**To:** Jack Reel  
**From:** Jeff Walton, Associate Planner; 910-341-3260  
**CC:** File;  
**Date:** 10/16/2013  
**Re:** Progress Apartments

**PROGRESS910**  
**4055 EMERSON STREET**  
 CITY OF WILMINGTON, NORTH CAROLINA  
**PROGRESS BUILDERS, LLC**  
 TREE REMOVAL PLAN

**G2.3**

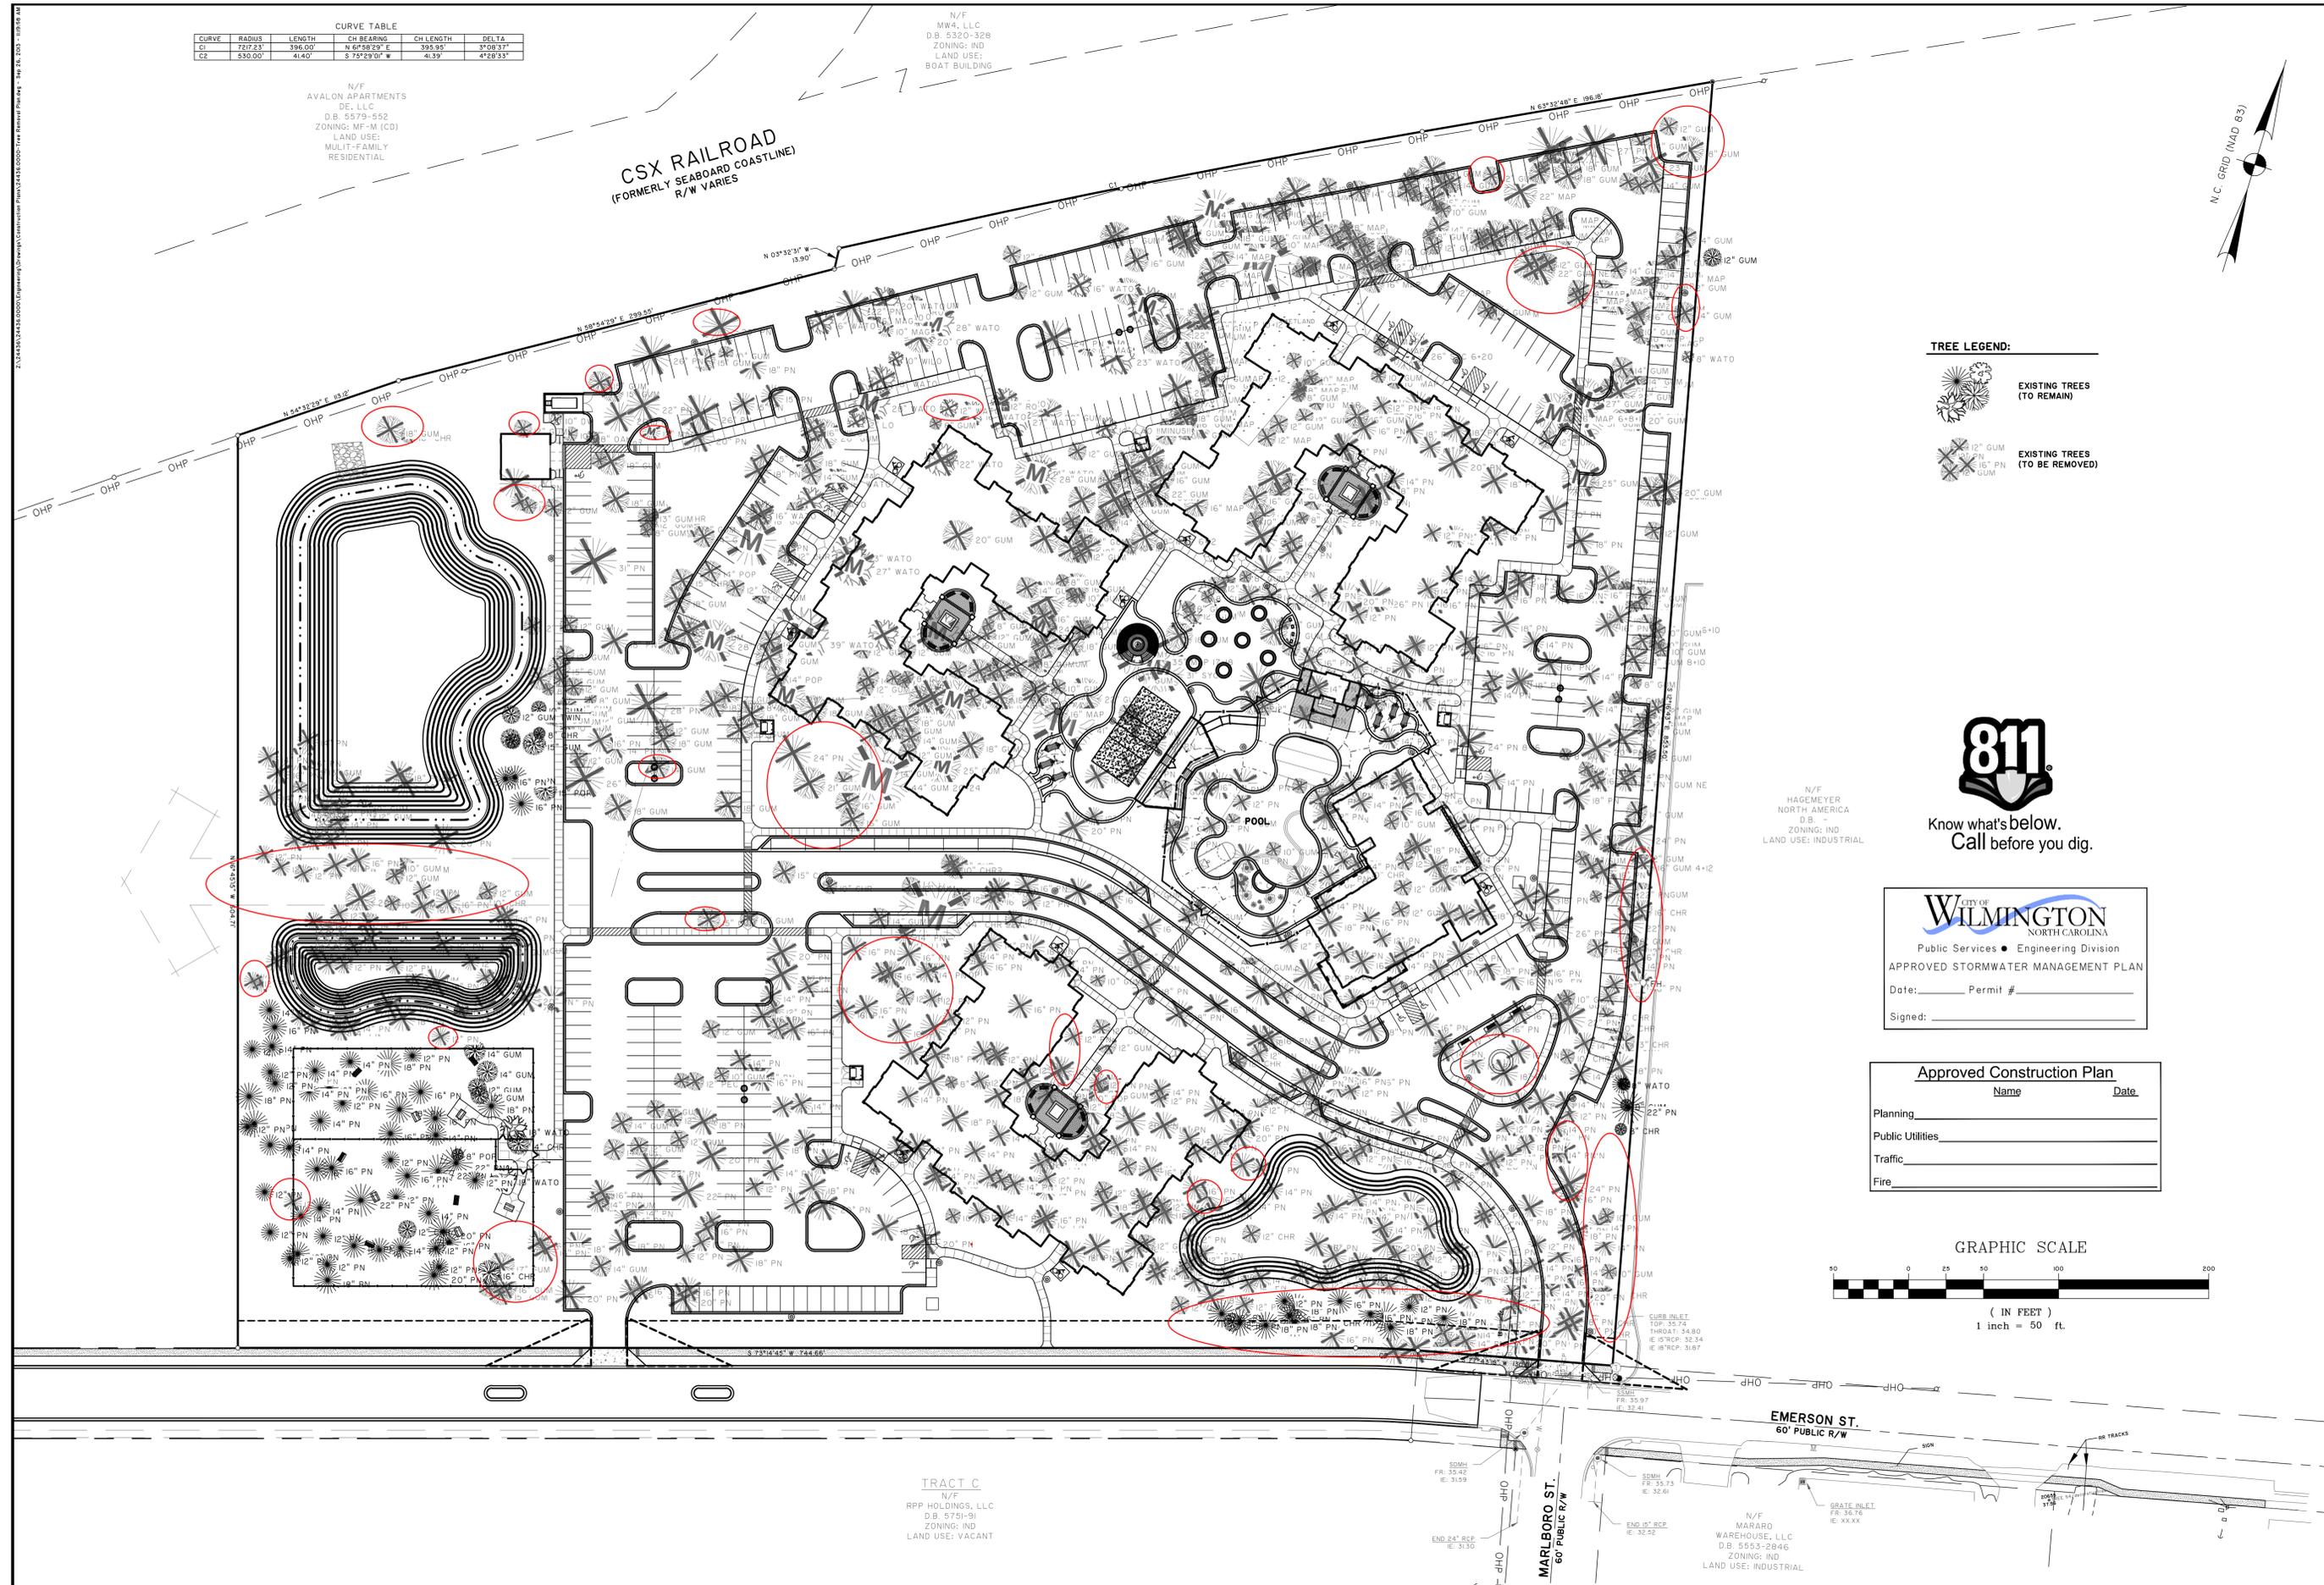
- Trees: I have attached a redline drawing of questionable tree removal. Let's work to determine if these trees can be retained or provide reasons on why they must be removed. Many appear not to be part of essential site improvements.
- The buffer shrubs in front of the parking lot facing Emerson Street need to be a minimum height of 36-inches when planted please amend the planting sheet.
